Barnes Avenue Sanitary Sewage Flow Diversion Project

Environmental Assessment

Amended Submission – May 22, 2015

Figure 3

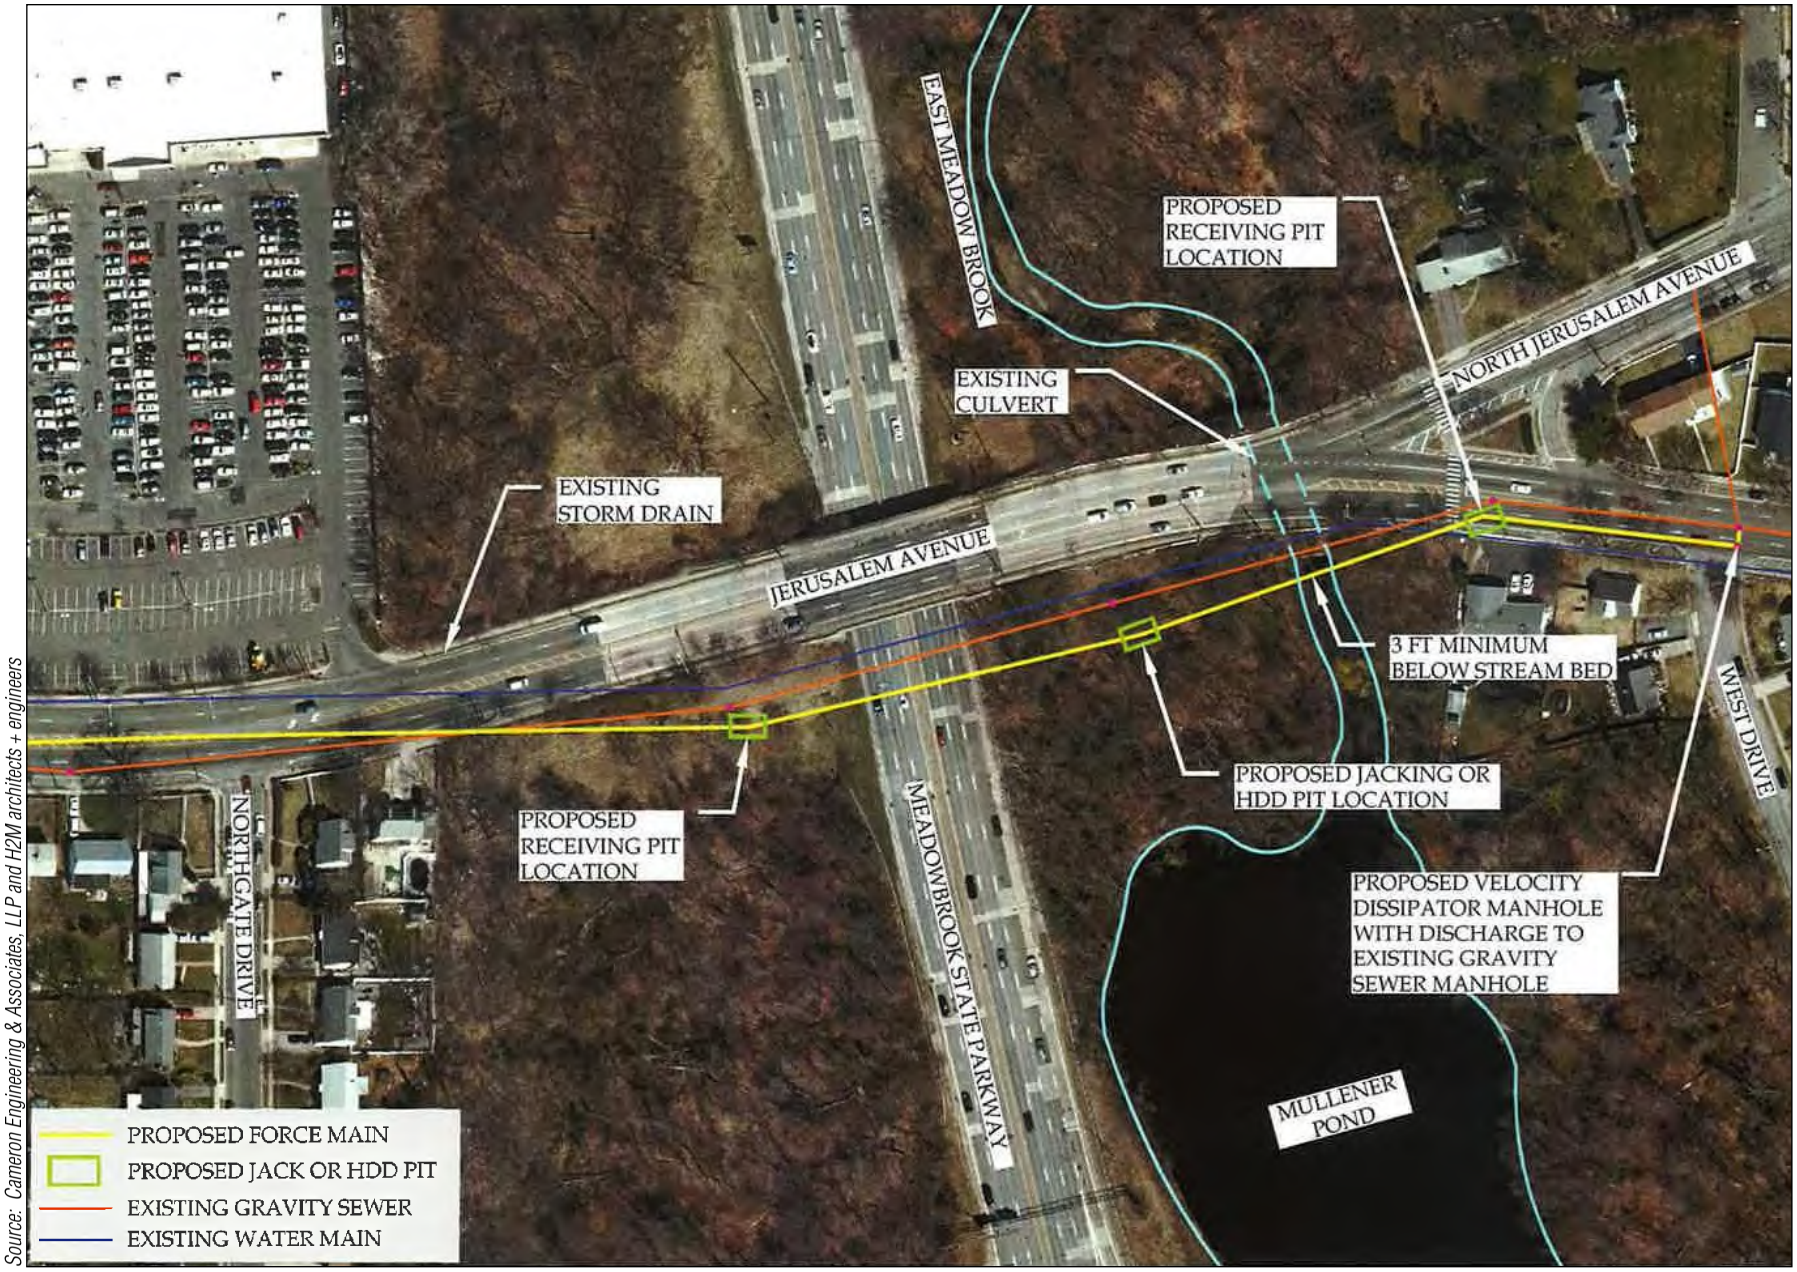
- Fig.3 of the assessment shows the existing and the planned sewer lines crossing a public water line at a point along Jerusalem Avenue, just east of Meadowbrook State Parkway. The vertical distance between a water line and a sewer line must be 18", according to Nassau County regulations.

(5) EPA States: "Fig.3 of the assessment shows the existing and the planned sewer lines crossing a public water line at a point along Jerusalem Avenue, just east of Meadowbrook State Parkway. The vertical distance between a water line and a sewer line must be 18", according to Nassau County regulations." *The vertical distance between the existing public water line and the planned sewer line crossing at a point along Jerusalem Avenue just east of the Meadowbrook State Parkway as shown on Fig 3 of the assessment will be maintained at 18" and in accordance with Nassau County regulations.*
